INCONTROL® TOUCH PRO™ PHASE 4 (18B) UPDATE

SERVICE ALERT

NO.: JA18TE-17
SA18TE-19
(ISSUE 2)

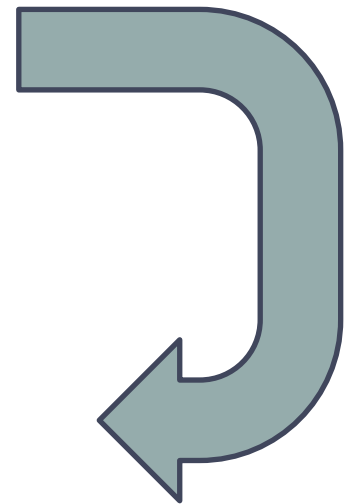
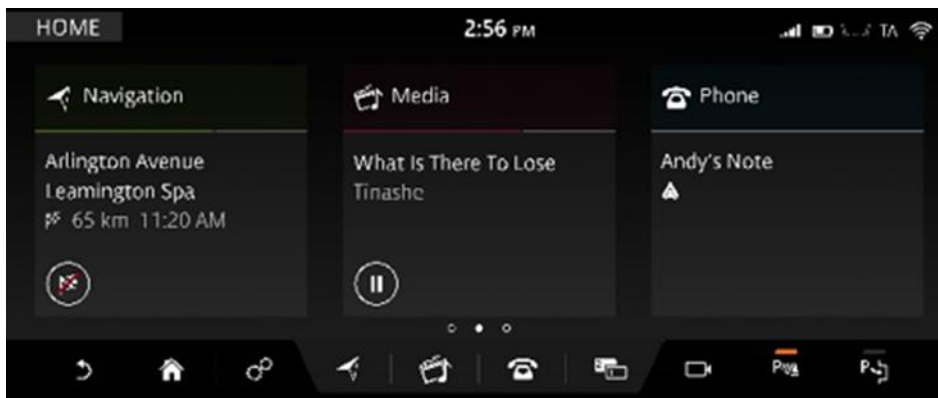
A major part of this update is to the look & feel of the single-screen system, which will change to match that of the InControl Touch Pro Duo system. **Once this software update is completed, it CANNOT be reversed.**

To clarify further, a vehicle with a single screen, where the customer is familiar with this Human Machine Interface (HMI) design:

After the Phase 4 (18B) update, the screen will be changed to have the look and feel of the InControl Touch Pro Duo HMI design:

Given this important and irreversible change to the way the customer directly interacts with their vehicle, we are requiring that you inform a customer with a single-screen system prior to performing this update. Only after the customer is informed and in agreement, you may proceed.
